Proposal of Supplement 5 to 0405 series of amendments to Regulation No. 48
(Installation of lighting and light-signalling devices)

Note: The text reproduced below was prepared by the experts from Japan in order to divide the documents into the AHS (Automatic Headlamp Switching) requirements and the other requirements. The proposal is based on ECE/TRANS/WP.29/2010/23, Corr.1 and WP.29-150-02. The modifications to ECE/TRANS/WP.29/2010/23, Corr.1 and WP.29-150-02 are marked in **bold** or ~~strikethrough~~ characters.

Model B

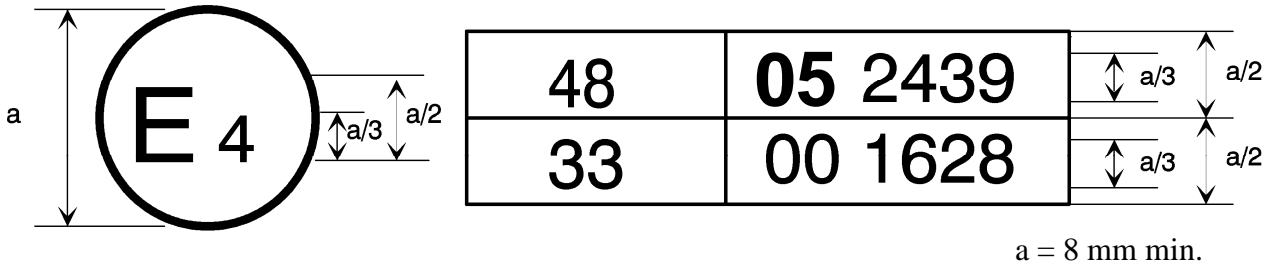
The above approval mark affixed to a vehicle shows that the vehicle type concerned has been approved in the Netherlands (E4) pursuant to Regulation No. 48 as amended by the **04 05** series of amendments and Regulation No. 33. 1/ The approval number indicates that, at the dates when the respective approvals were given, Regulation No. 48 was amended by the **04 05** series of amendments and Regulation No. 33 was still in its original form.
